#### Knox County Procurement Division Addendum I to Invitation for Bids 3343 Roadway Improvements to Solway Road

Addendum Date: January 17, 2023 <u>Buyer:</u> Brian Hubbs

# CONSTRUCTION OF ROADWAY IMPROVEMENTS TO SOLWAY ROAD BID NO. 3343

TYPICAL SECTION

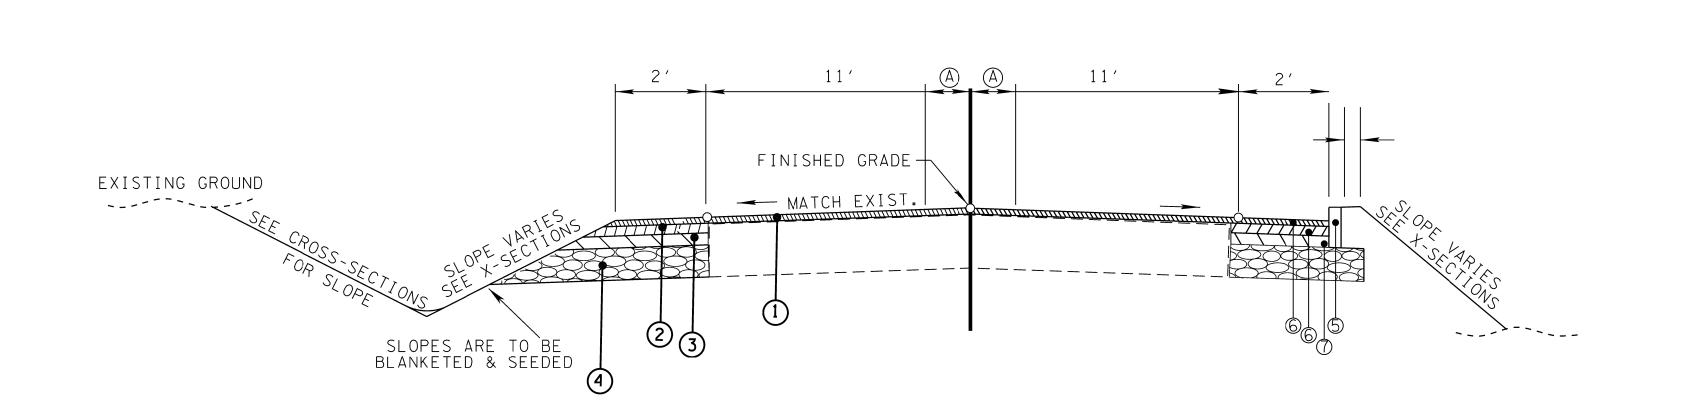
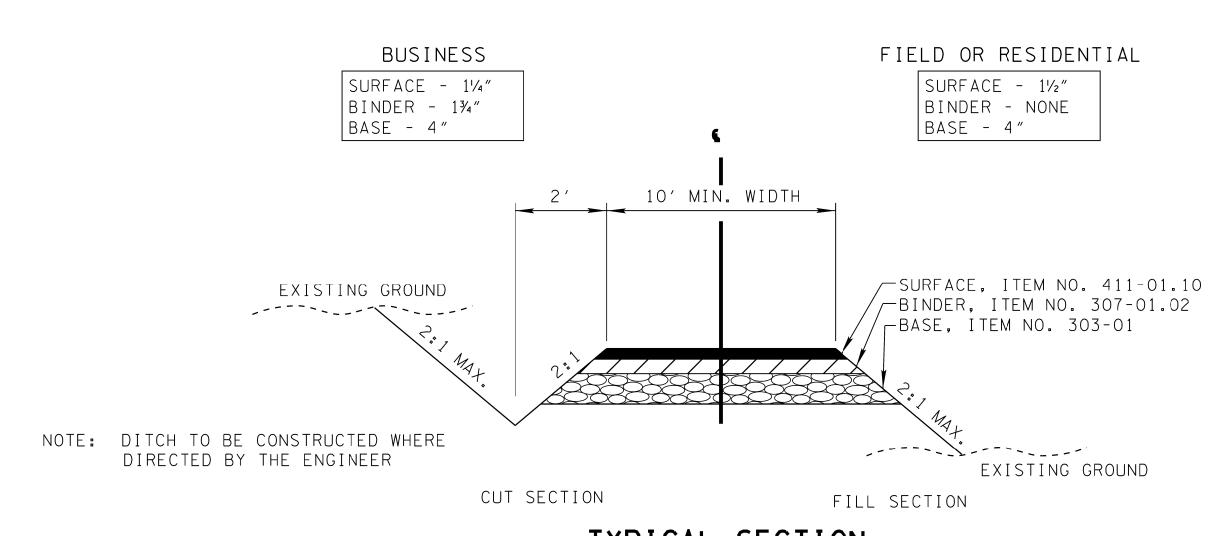
Question 3: Item No. 307-02.01, shown on the Estimated Roadway Quantities on Sheet 3, the Typical Section's Proposed Pavement Schedule on Sheet 4 and Bid Form is for PG70-22. Is that what is intended for this project, or should the item number be changed to Item No. 307-01.01, which is used for PG64-22?

Answer 3: Item No. 307-02.01 has been changed to Item No. 307-01.01 on the Estimated Roadway Quantities on Sheet 3, the Typical Section's Proposed Pavement Schedule on Sheet 4, and Bid Form. See attached Sheet 3, Sheet 4 and revised Bid Form.

ROBERT G. CAMPBELL & ASSOC., L.P.	00114/41/10040		DESIGNED BY	CHECKED BY	SCALE	SHEET	$\overline{}$
1 1/17/23 ITEM NO. 307-02.01 HAS BEEN CHANGED TO 307	7-01.01. GG RGC	CONSULTING ENGINEERS	SOLWAY ROAD	TYPICAL SECTION	GG	RGC	1" = 50'	NO (	4)
NO. DATE DESCRIPTION	BY CKD. RGC&A		IZNIOV COLINITY TNI		DRAWN BY	DATE	FILE NO.	1	$\mathcal{A}$
REVISIONS		KNOXVILLE, TENNESSEE	KNOX COUNTY, TN		NCG	SEPT. 2022	20043	OE 20 SI	4FFTS
